Technical Service Bulletin

**Solitude 360RL Slide Room Flex-Guard Strap -
DS Dinette Slide**

16-005

Solitude 360RL

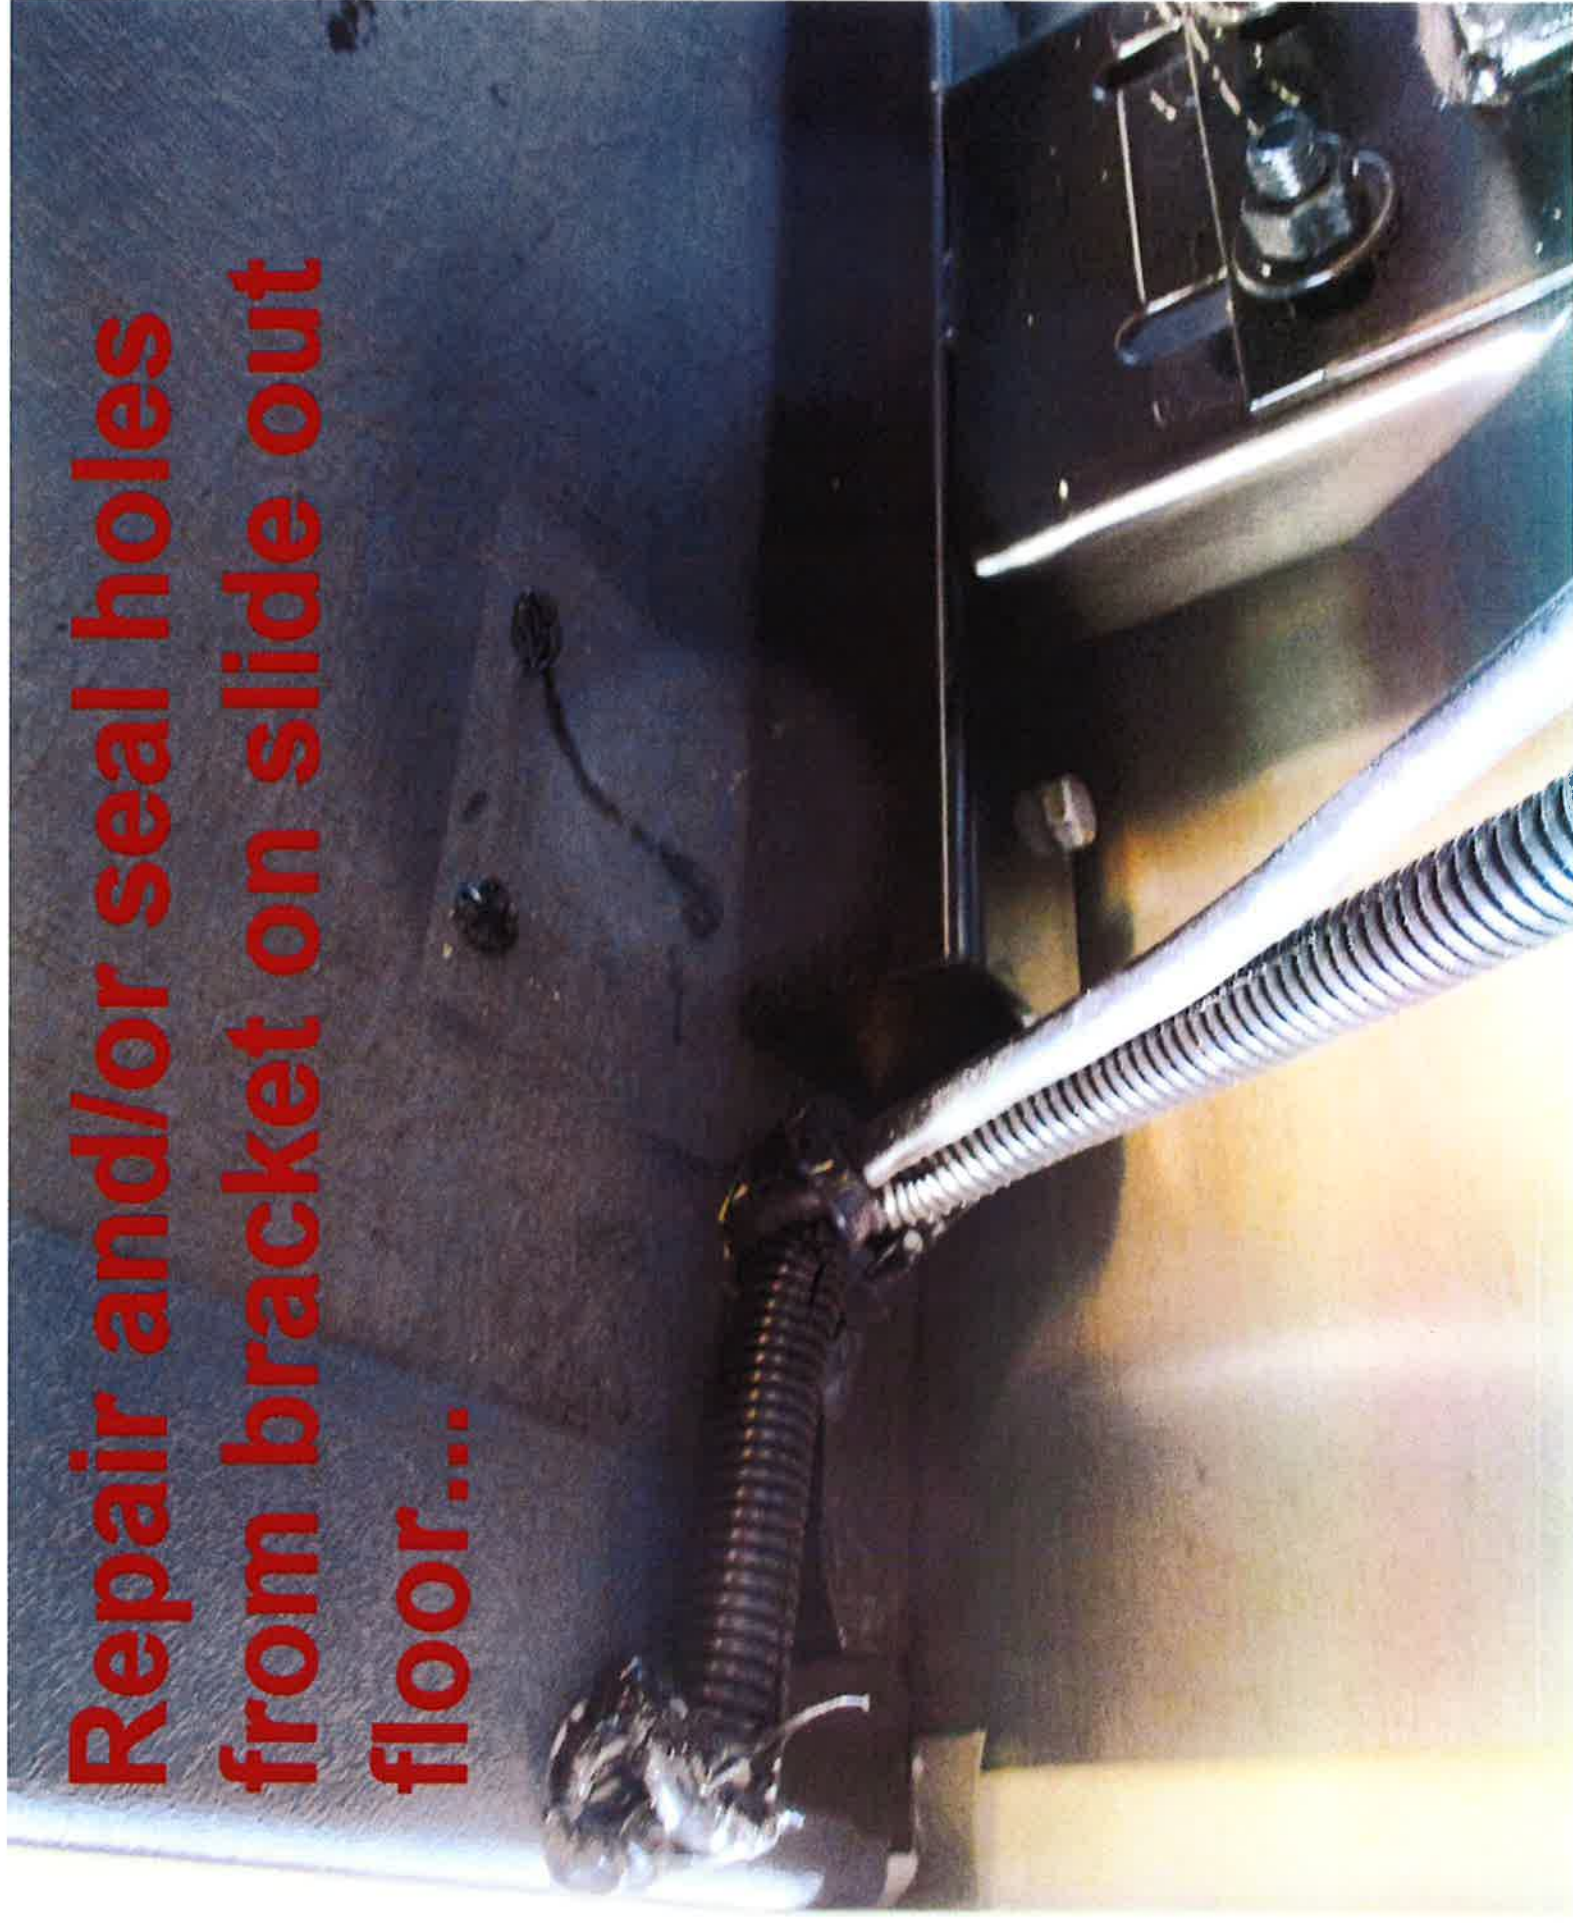
**Remove screws
from front side of
guide...**

**Cut zip tie securing loom
and SJO cord to bracket...**

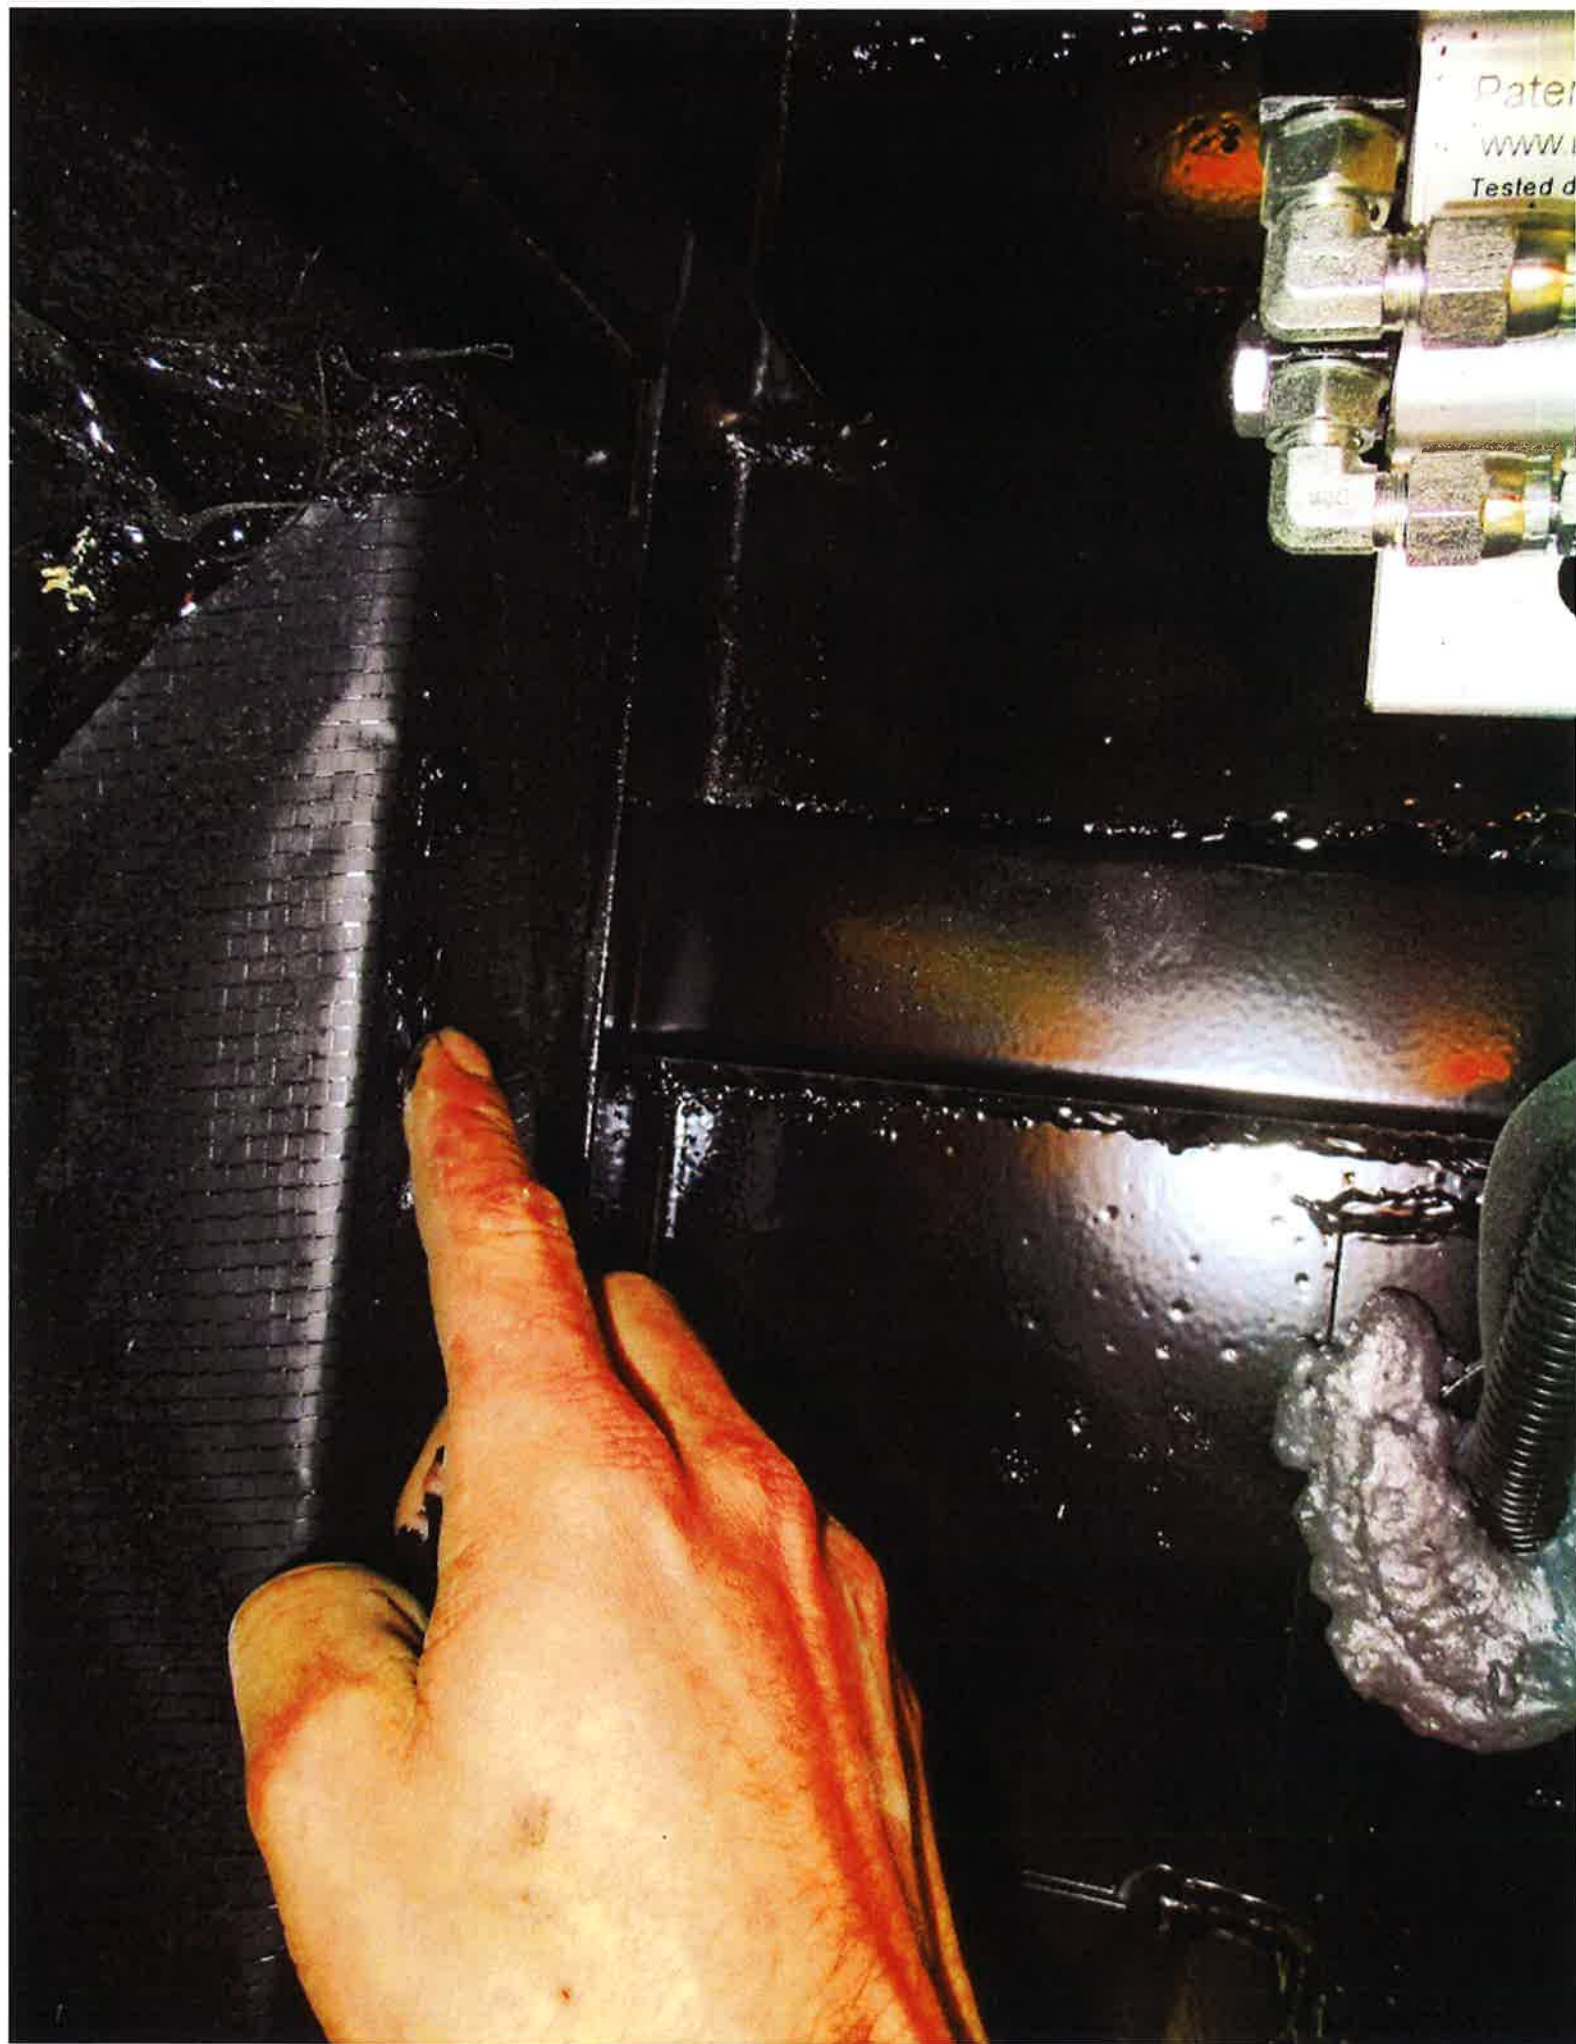
Remove guide bracket...

**Repair and/or seal holes
from bracket on slide out
floor...**

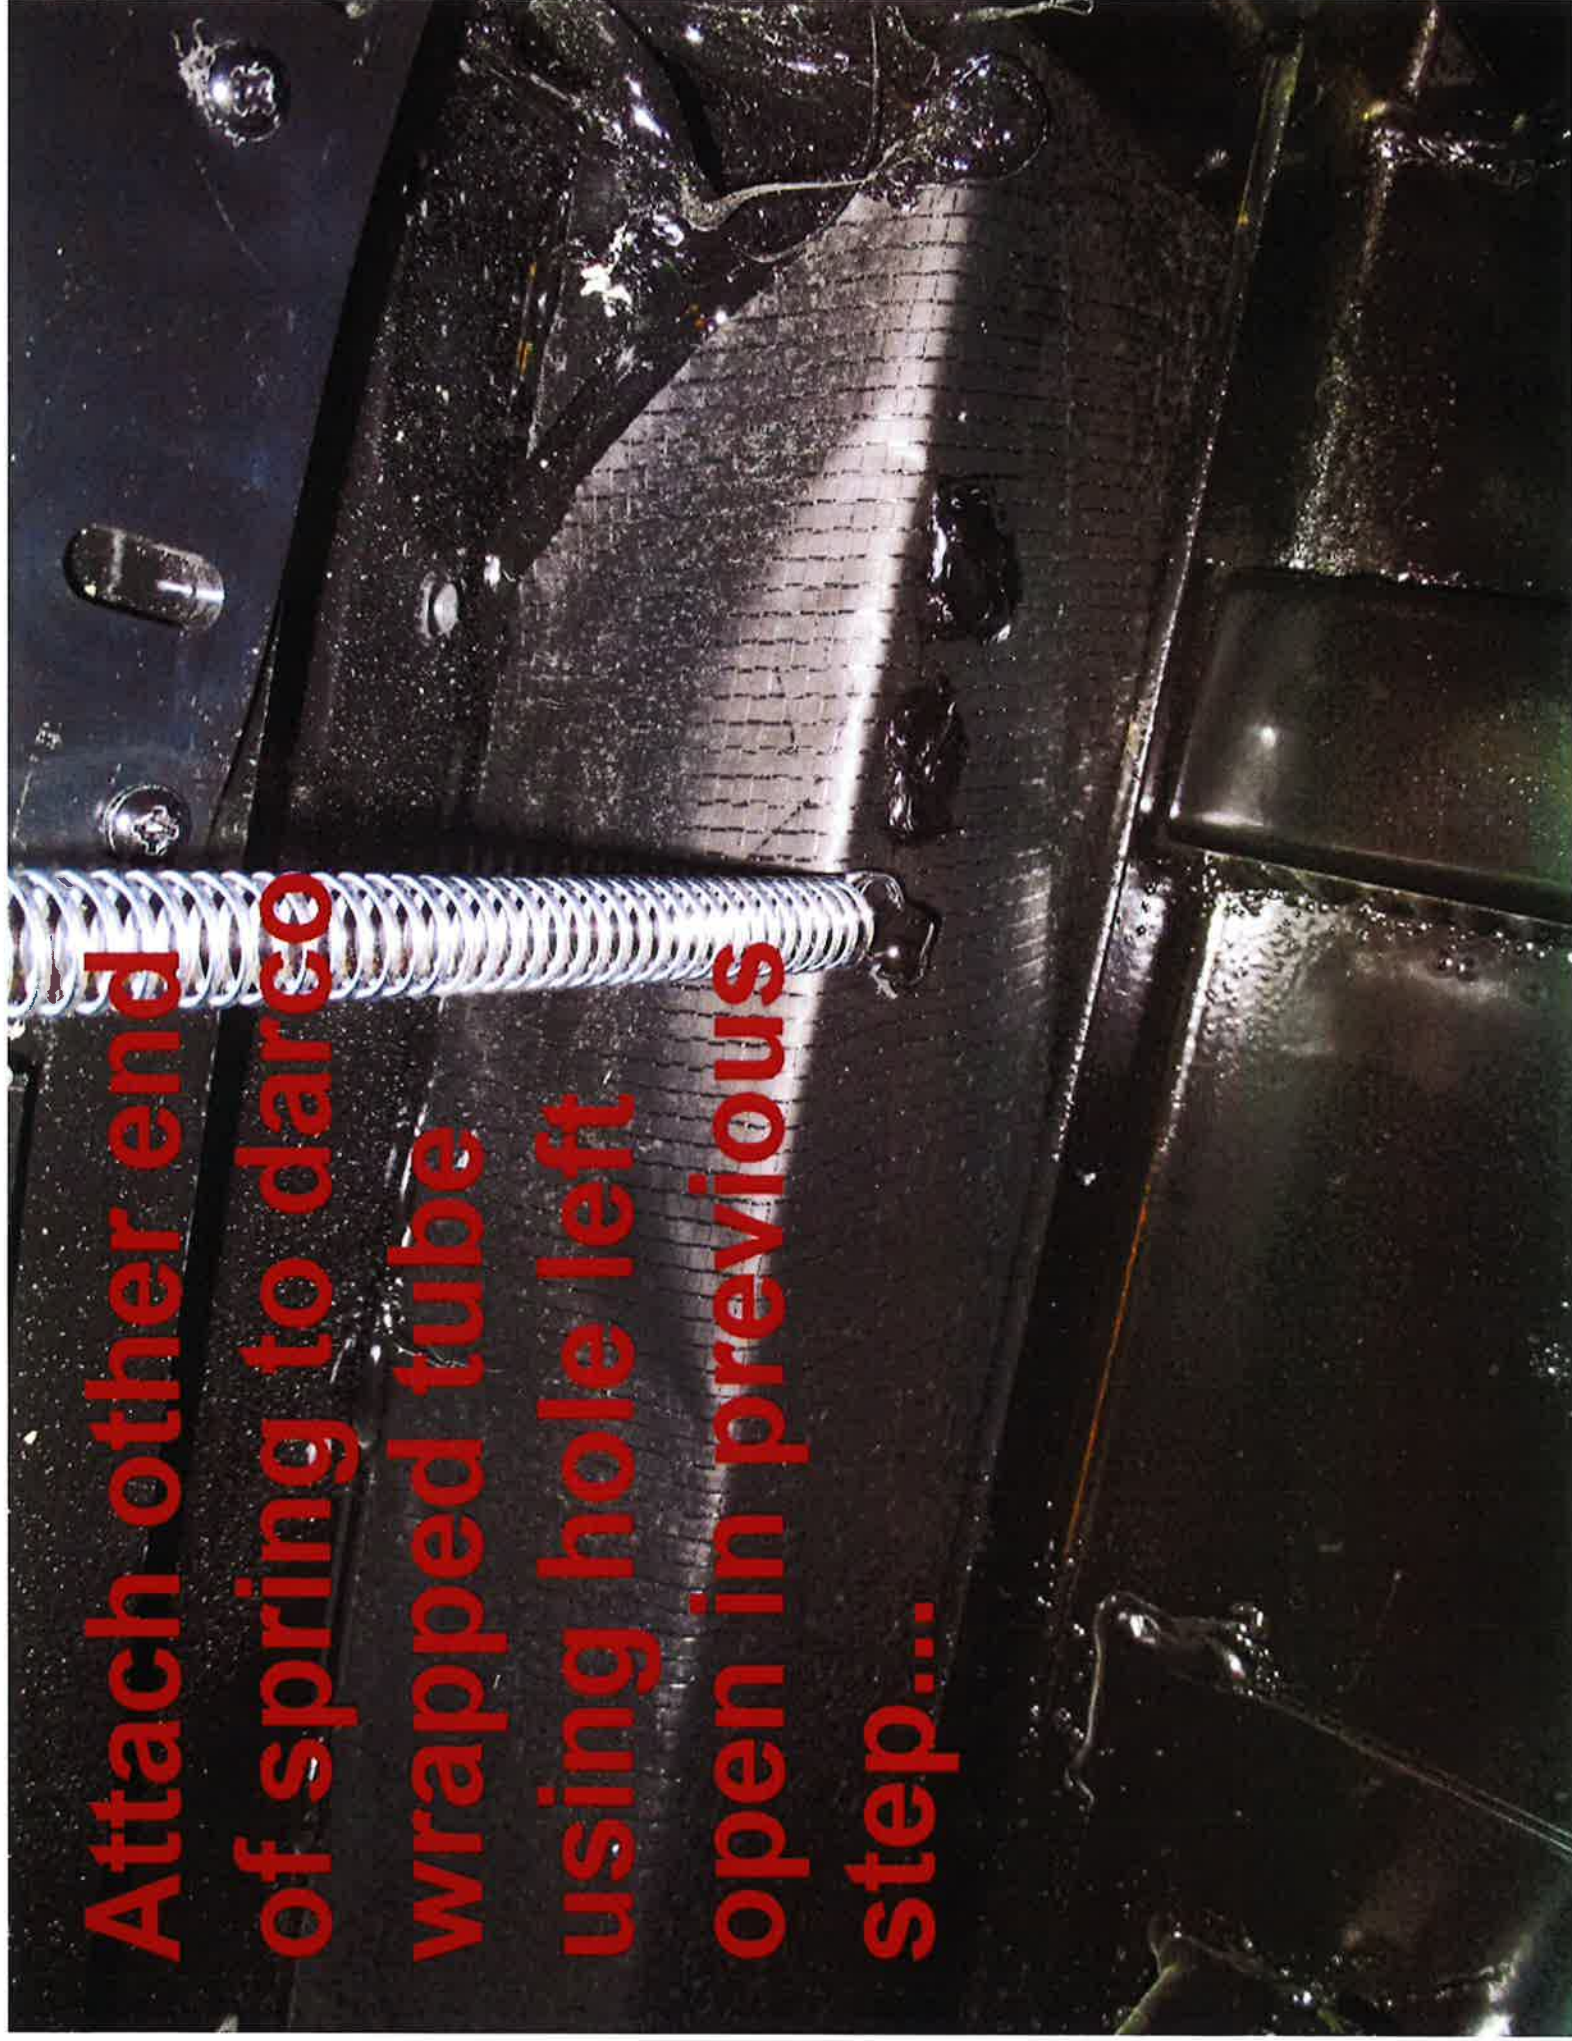
**Reseal/repair front two
holes from belt bracket
leaving the 3rd open...**

**Attach end of
spring to slide out
floor just in front
of the room bar...**
